**New Albany Planning Commission**  
Monday, July 20, 2026 Meeting Minutes - DRAFT

### **FDP-32-2026 6600 New Albany-Condit Road Final Development Plan**

#### **FDP-04-2026 Edgehill Final Development Plan**

**6600 NEW ALBANY-CONDIT ROAD OFFICE  
FINAL DEVELOPMENT PLAN**

Waivers A & B. Waivers to reduce the minimum percentage of lot width that a townhome building must occupy (90% to 76%); and to reduce the minimum required lot size for townhome lots (25' to 22').

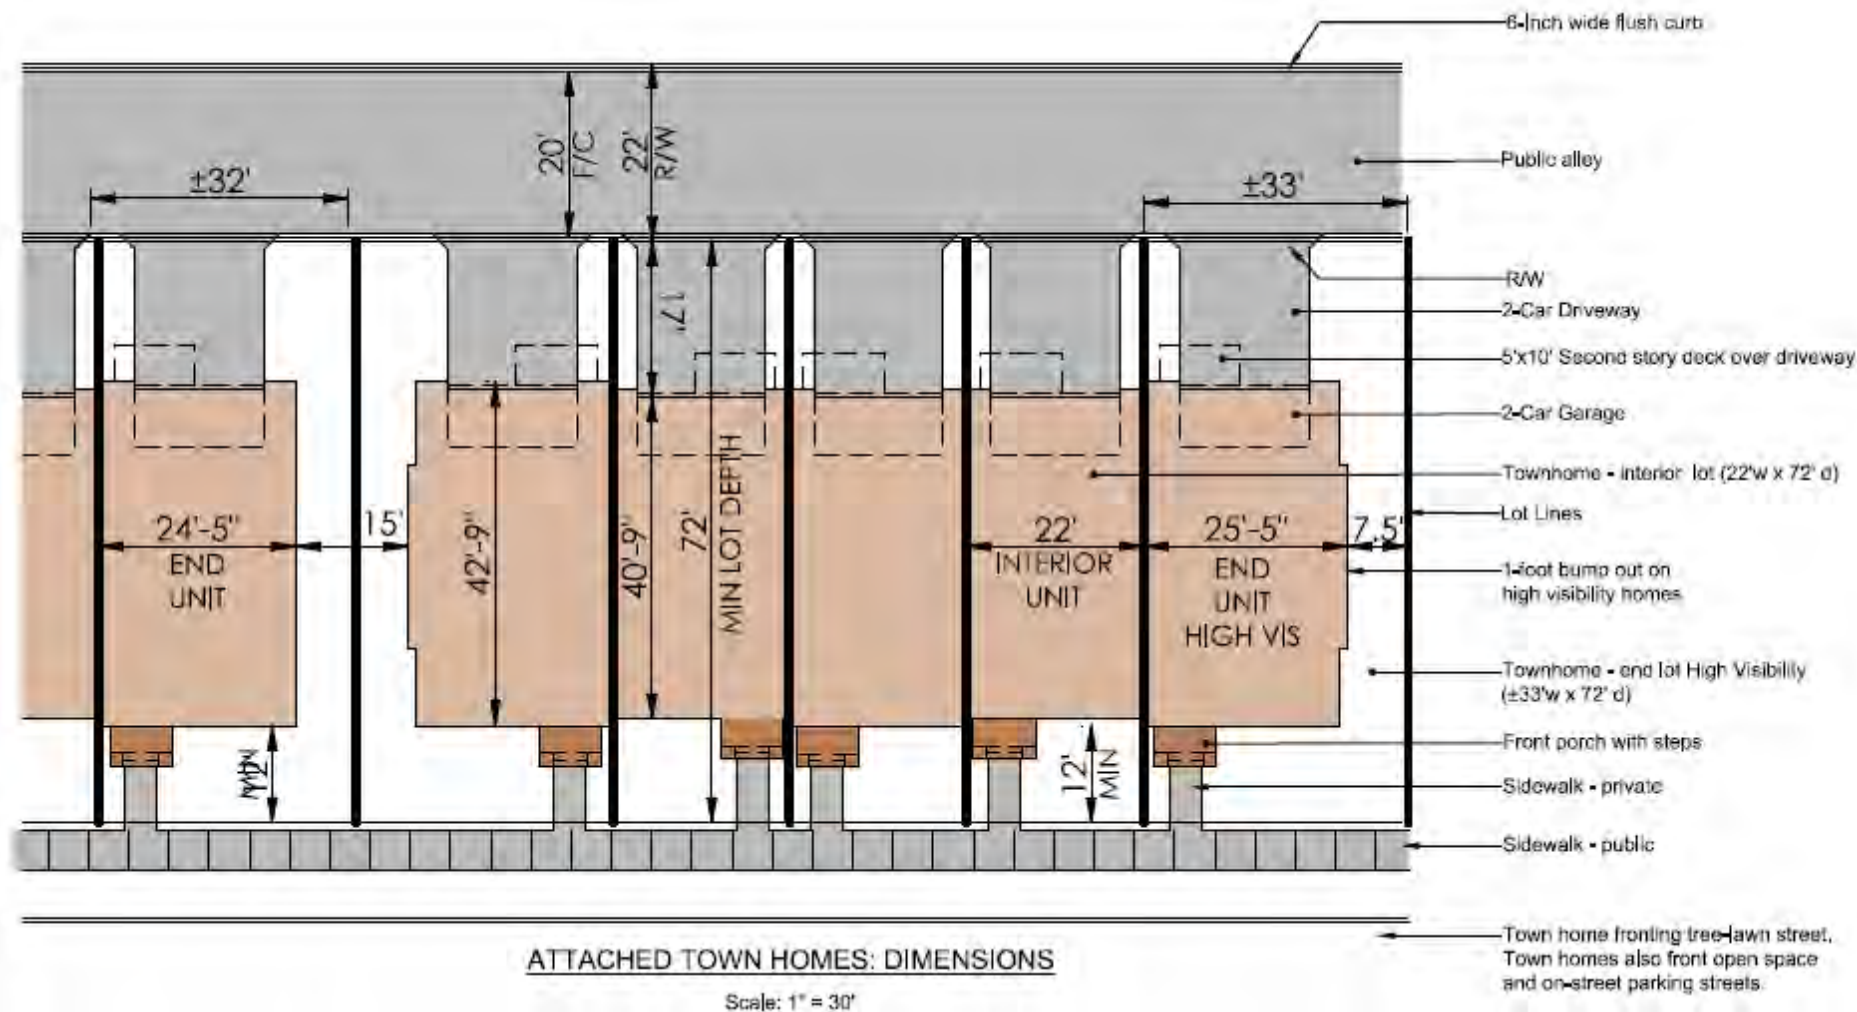
Planner II Saumenig explained that taken together, Waiver A and Waiver B provide a more appropriate development pattern for the Village Center. Strict application of the lot coverage rule would result in 6-foot spacing between the side facades of the townhomes, which, due to the curvature of the road, will look like an endless row. The requested 22-foot interior width is consistent with the compact form of urban townhomes and would create a 15-foot side yard. The reduction in interior width coupled with the added end-unit spacing will enhance the streetscape.

Waiver C. Waiver to allow small surface parking areas not to be located behind primary buildings.

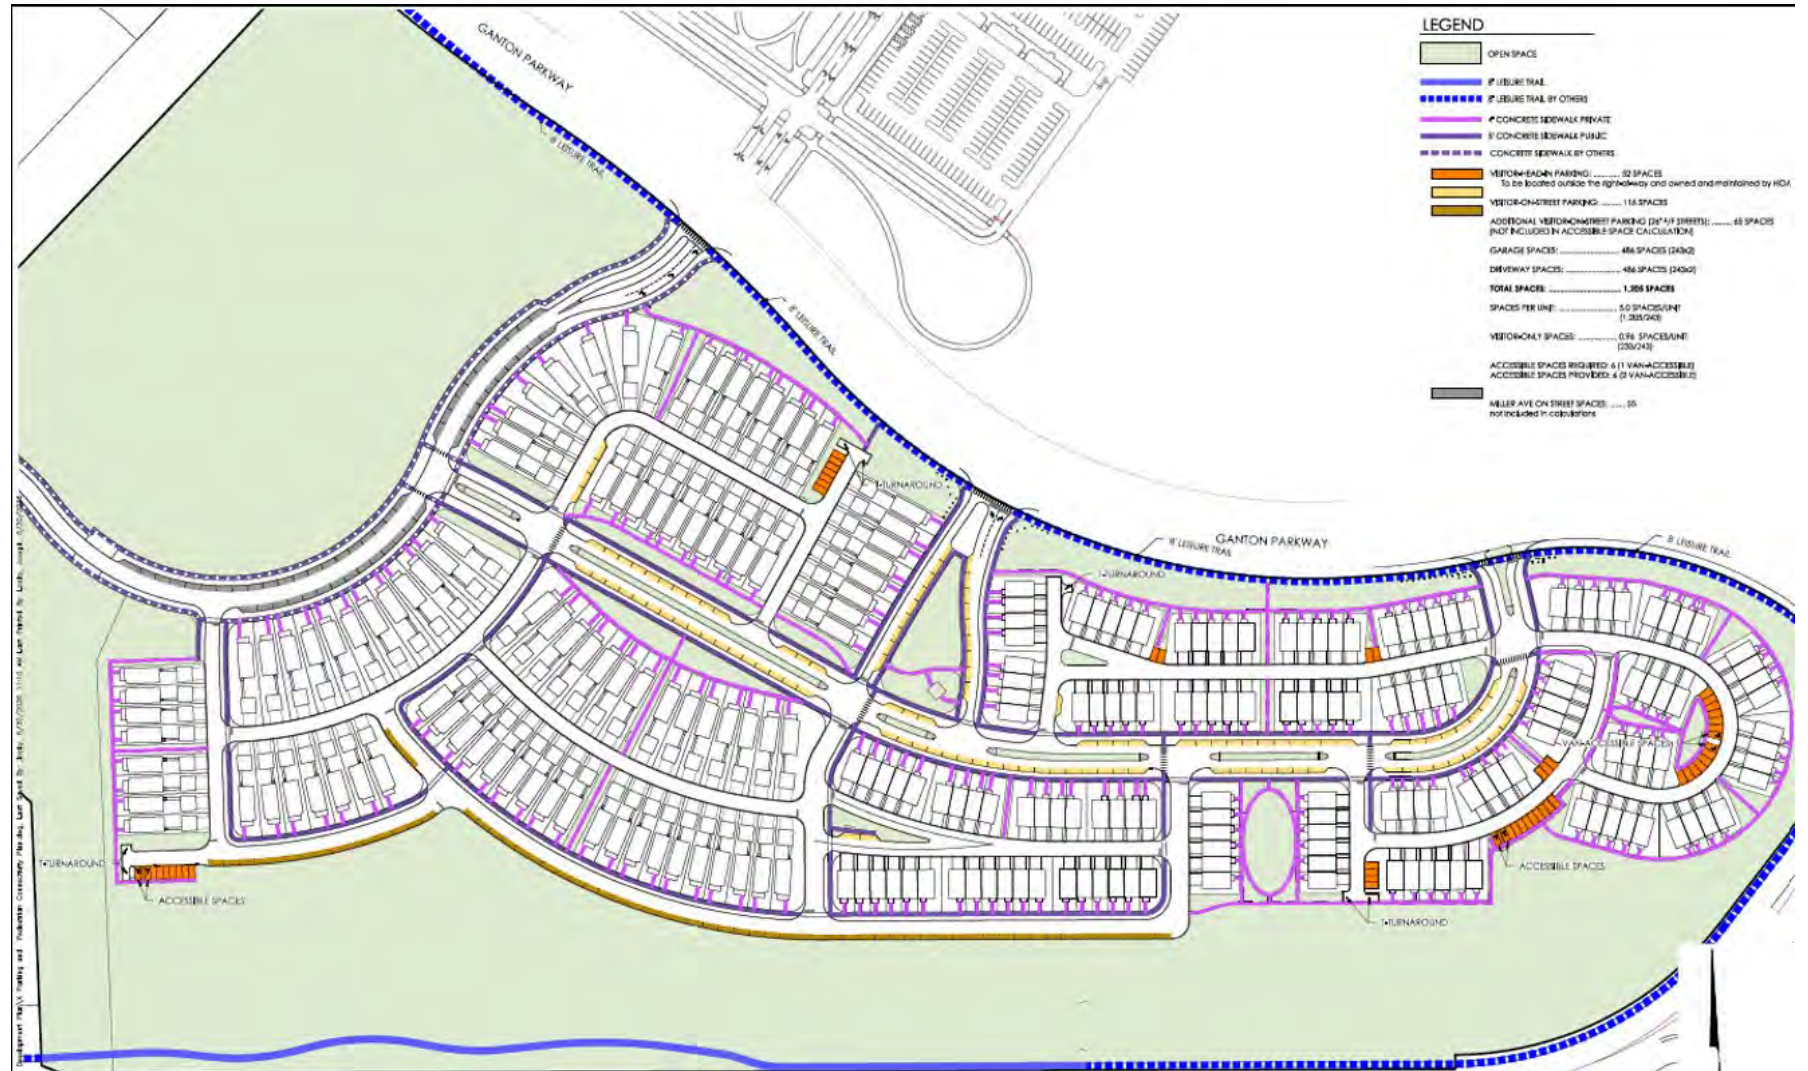
Mr. Barkan added that each unit has an 8-foot driveway in addition to the 2-bay garage, so there are four spots per unit.

Planner II Saumenig added that the applicant is above and beyond the minimum parking requirements.

Waiver E. Waiver to eliminate the requirement for shutters, when used on a building elevation of a home, must be used on all windows of that elevation.

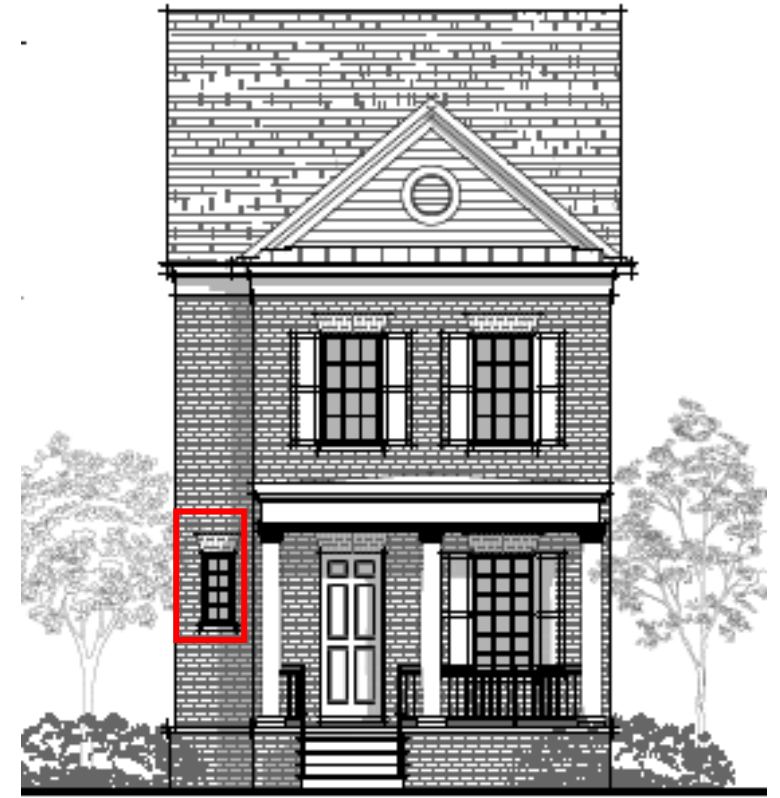
Planner I Henderson responded that the shutter requirement does not apply to townhomes.

6. Waiver from Section 2 of the Village Residential DGRs, subsection II.B.6, to allow primary home entrances to face open space or parkland rather than a street.

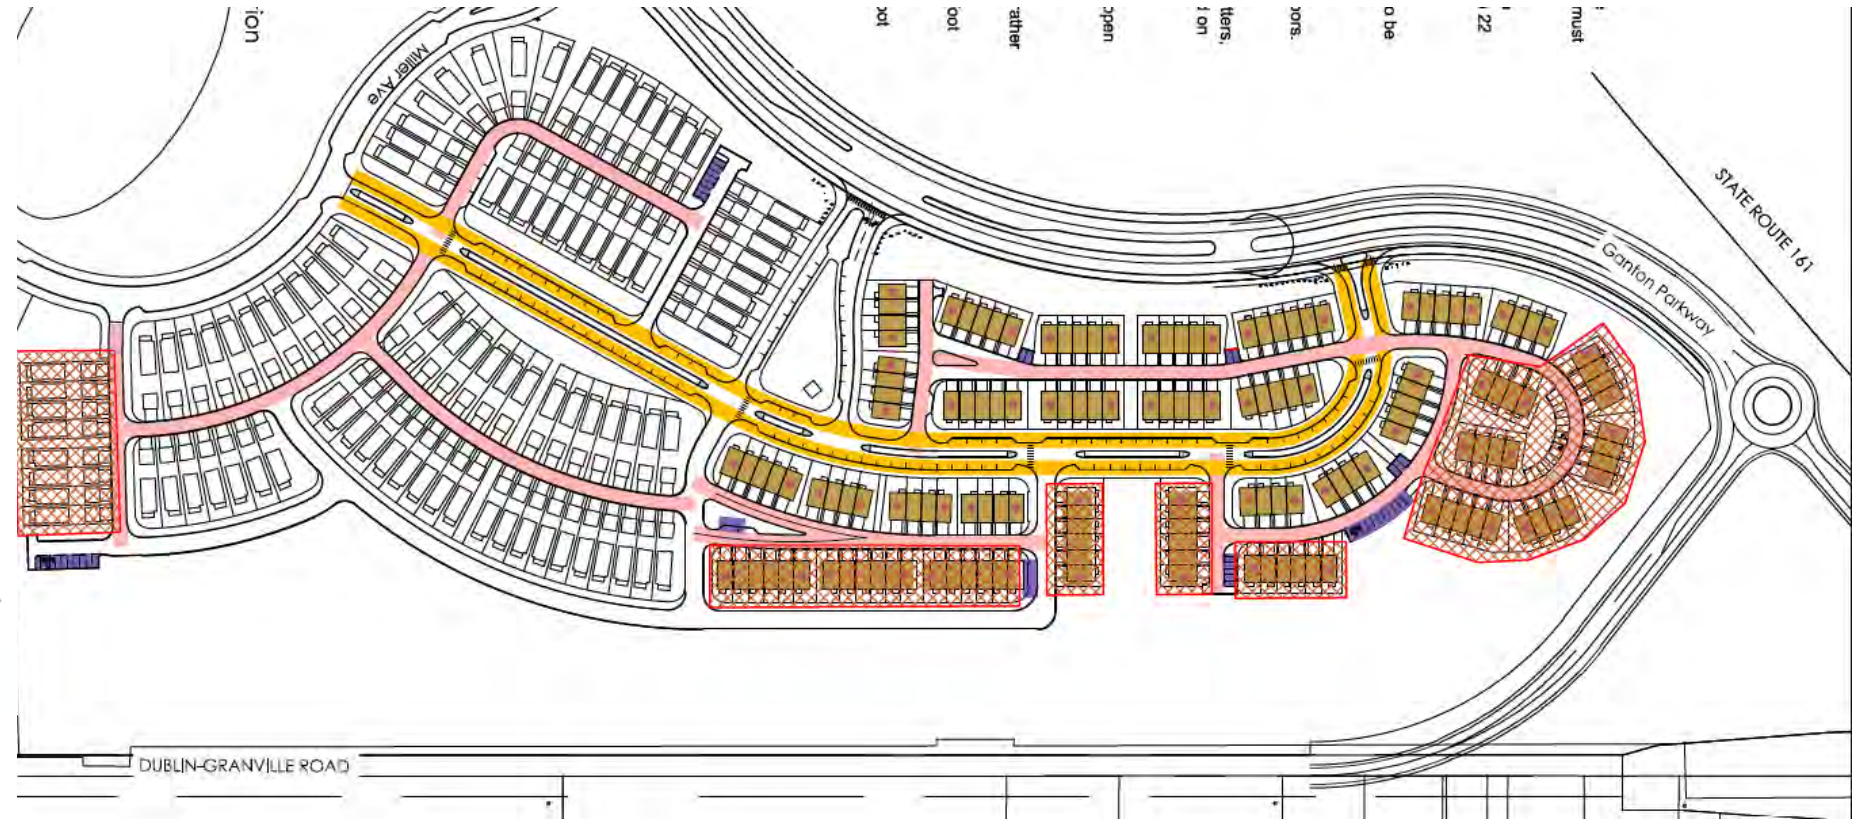
Chair Kirby noted the waiver exhibit page in the notebook and the waiver map in the presentation show where this waiver would apply in red crosshatching. He asked whether wayfinding signs could assist with navigation toward front doors.

Commission Member Larsen stated he is having trouble with this waiver. It breaks the connectivity of the Strategic Plan. He explained that he thinks this is safety issue, and lack of connectivity is not as safe as if there is a street in front of the homes.
